SERVICE BULLETIN

No. 708

Piper Aircraft Corporation

PA-31 and PA-31-325 Takeoff Flaps

42334

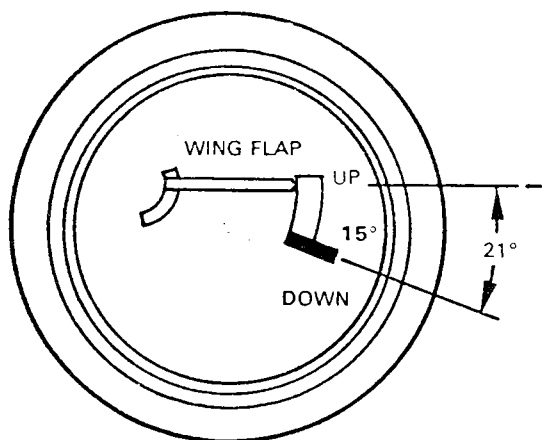
1. For indicators of the AC or Rochester type, Part Number 42334-00, 55650-02, or -03, 55564-00, 55567-02 or -03, and 55991-03, -04, -06 or -07, use the following instructions:
 - a. 42334-00, 55564-00, 55567-00 and 55650-00 indicators must have 1/16" by 1/4" radial line placed at the end of the first white arc (15°).
 - b. 55991-06 and -07 indicators must have a 1/16" by 1/4" radial line across the white arc exactly in the middle of the complete white arc (15°).

- c. All indicators must have the legend "15°" in 1/8" letters added adjacent to the 15° radial, such that it does not interfere with any other legend.

71128 SERIES (Hickok type)

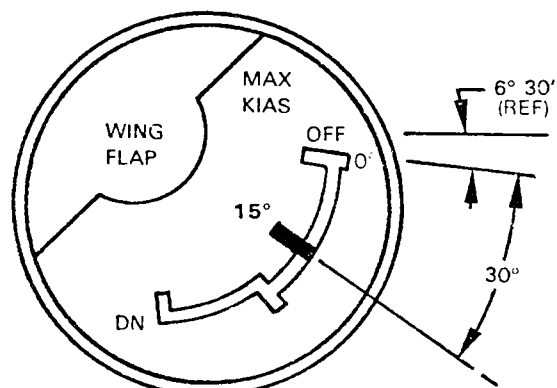
2. For the indicator of the Hickok type, Part Number 71128-02, -03, -05, -06, -09 or -10, use the following instructions:
 - a. The 71128-02, -03, -05, and -06 indicator face has a wide arc to the 15° position with a wide radial at 15°. Mark a "15°" legend in 1/8" letters adjacent to the 15° radial but in such a position that it does not interfere with any other legend.

- b. 71128-09 and -10 indicator face has to have a 1/16" wide x 1/4" long radial line placed across the white arc 30° down from the top of the arc and a "15°" legend in white letters must be placed adjacent to the 15° radial but in such a position that it does not interfere with any other legend.
